HEARING DATE: March 2, 2023
Continued from: February 2 and 16, 2023

TO: Planning & Zoning Commission

FROM: Sonya Allen, Associate Planner
 208-884-5533

SUBJECT: Newkirk Neighborhood AZ, PP
 H-2022-0088

B. Preliminary Plat (dated: 10/21/22) – NOT APPROVED

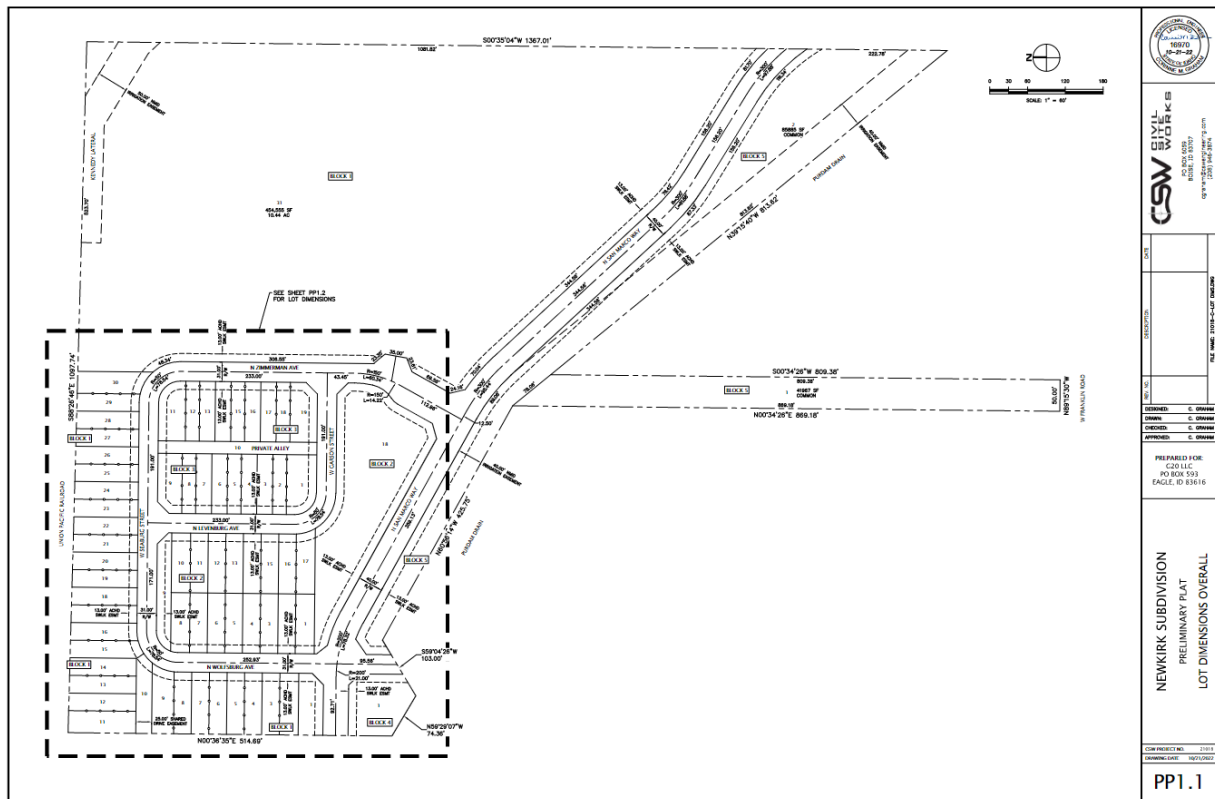
This property and three (3) properties to the south take access from Zimmerman Ln., a private street; two (2) of these properties don't have public street frontage. **ACHD is requiring Zimmerman Ln. to be dedicated and improved as a local public street in order to provide a north/south street connection between Franklin Rd. and the collector street, public street frontage for the two parcels to the south, and access to Ascent Subdivision from a local street, which will enable their temporary vehicle access to be converted to emergency and pedestrian access only. The plat should be revised accordingly.**

A street is planned to stub at the south boundary of the subject property from Alamar Subdivision near the southwest corner of this site per the approved preliminary plat ([H-2022-0004](#)). The development agreement for Alamar (Inst. #[2022-065010](#)) states the final alignment at the north property line shall be

C. Common Drive Exhibit – *NOT APPROVED*

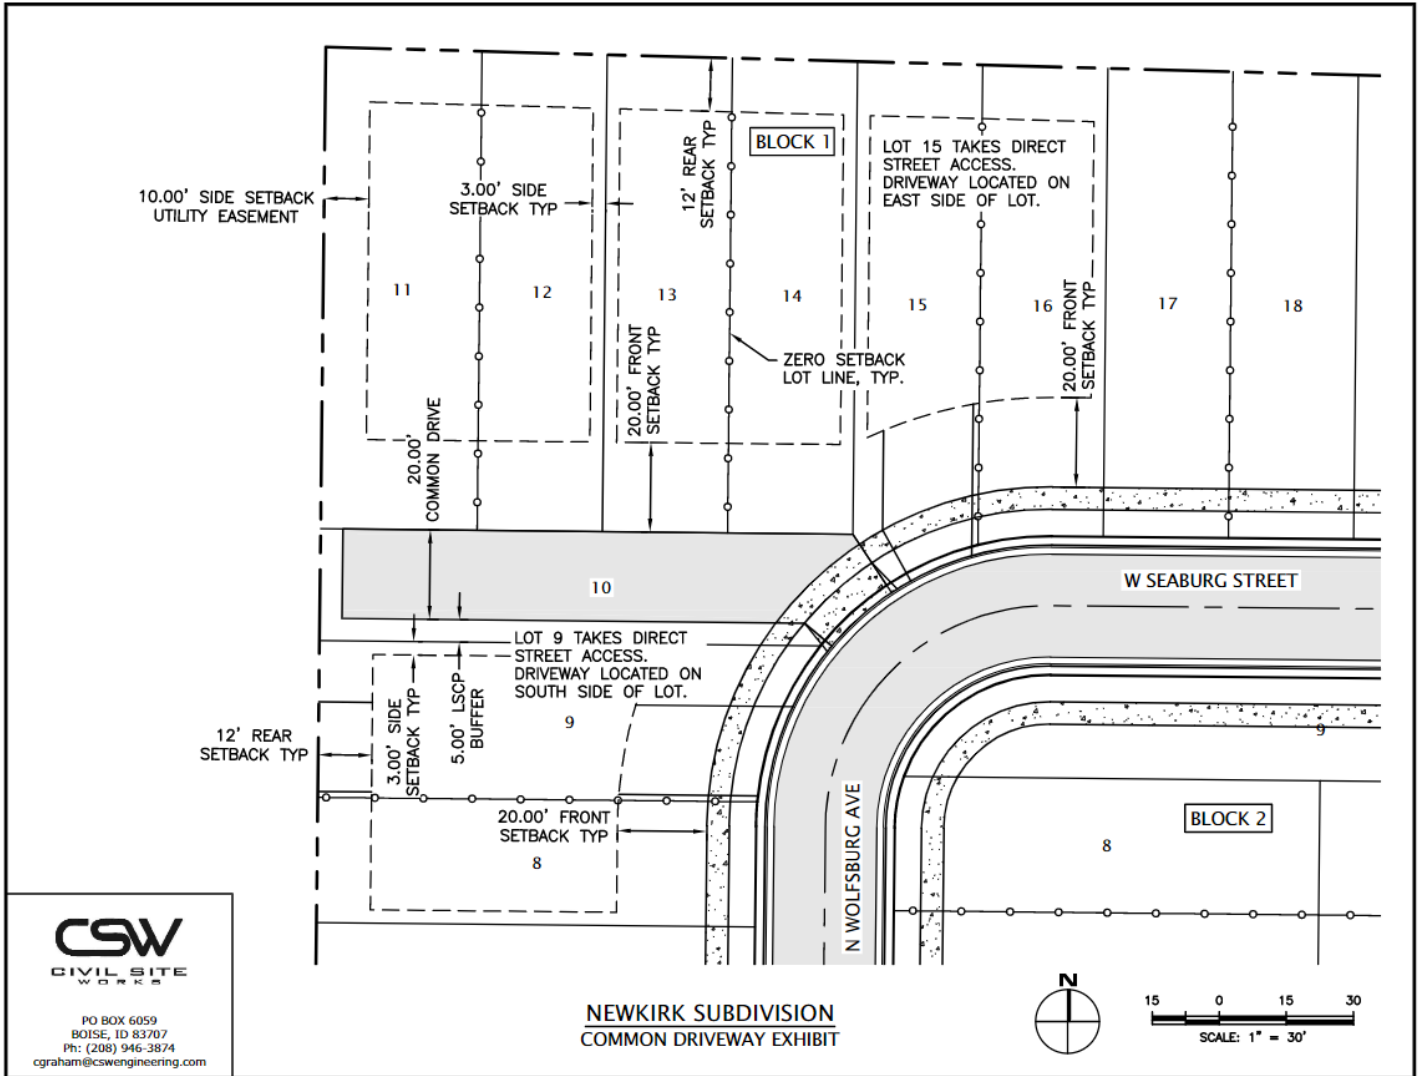
Common Driveway (UDC [11-6C-3D](#)): One (1) common driveway is proposed at the northwest corner of the site on Lot 10, Block 1 for access to Lots 11-14, Block 1. Common driveways are allowed to serve a maximum of four (4) dwelling units; in no case shall more than three (3) dwelling units be located on one (1) side of the driveway. **A total of four (4) dwelling units are proposed on the north side of the driveway; the final plat and common driveway exhibit shall be revised to depict a maximum of three (3) units on one (1) side of the driveway as required; or, alternative compliance may be requested as set forth in UDC [11-5B-5](#).**

5. The common driveway shall be designed and constructed per the standards listed in UDC [11-6C-3D](#). **Revise the common driveway exhibit in Section VIII.C to reflect a maximum of three (3) dwelling units on one (1) side of the driveway as set forth in UDC 11-6C-3D.1; or, alternative compliance may be requested as set forth in UDC [11-5B-5](#).**

Tree 3

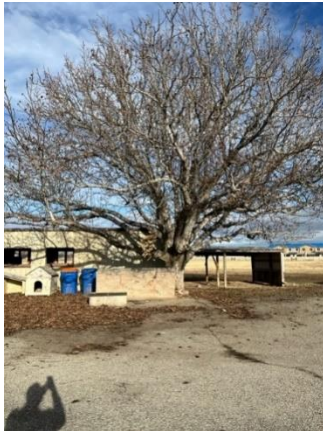
There are several existing trees on this site that will be removed with development. An existing tree inventory and mitigation plan is included in Section VIII.H. **Mitigation is required to be provided per the standards listed in UDC [11-3B-10C.5](#); calculations demonstrating compliance should be included on the landscape plan submitted with the final plat application.**

- b. Include mitigation calculations on the plan for existing trees that are proposed to be removed in accord with the standards listed in UDC [11-3B-10C.5](#) and the exhibit in Section VIII.H.

DESCRIPTION
BUILDING TYPE 2 EXTERIOR ELEVATIONS

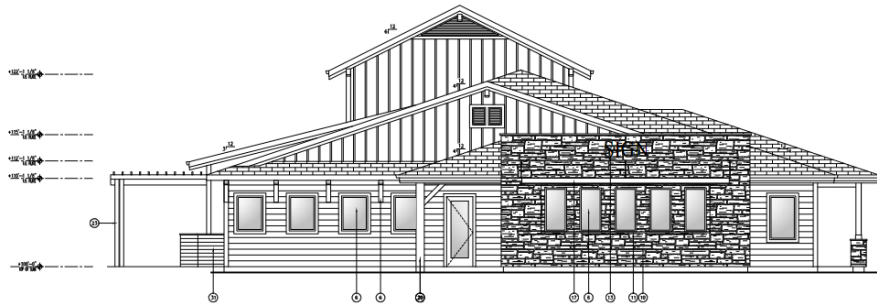
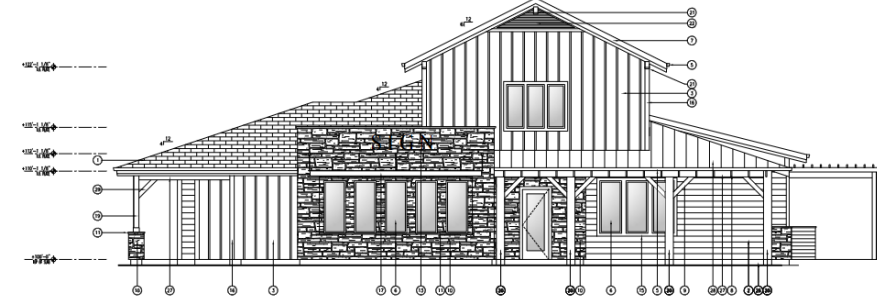
Continuity of building sizes is proposed but with little variation in form and design of any of the structures. The street-level and upper-level architectural detailing offer few differences in the attached and townhome units; architectural detailing between the first two (2) stories on the multi-family units are generally the same with a different siding material on the third story.

Elements that anchor and emphasize pedestrian scale are windows, doors, weather protection/roofs over windows and doors, window pop-outs and recesses – the addition of masonry accents on the first floor facades would assist in emphasizing pedestrian scale and durability & quality of materials. Building entrances are not placed at the street on attached units as desired, they are located at the rear of the garages away from the street with garages facing the street. Building entrances for the townhomes face the street as desired because these units are alley-loaded.

The proposed elevations are *not* approved and should be revised to incorporate traditional neighborhood design elements as set forth in the TMISAP, as noted above in Section V, and in the Architectural Standards Manual (ASM). Revised elevations should be submitted that demonstrate compliance with these guidelines and standards prior to Commission action on this application.

Revisions to the plans and elevations are necessary to meet this design criteria. More architectural variety and details should be provided to differentiate between the street-level and upper-level units. Lighting at a pedestrian-scale should be provided on the buildings facing the street and internal walkways. A different product type should be provided for the attached units with garages behind the units, building entrances facing the street with front/side porches.
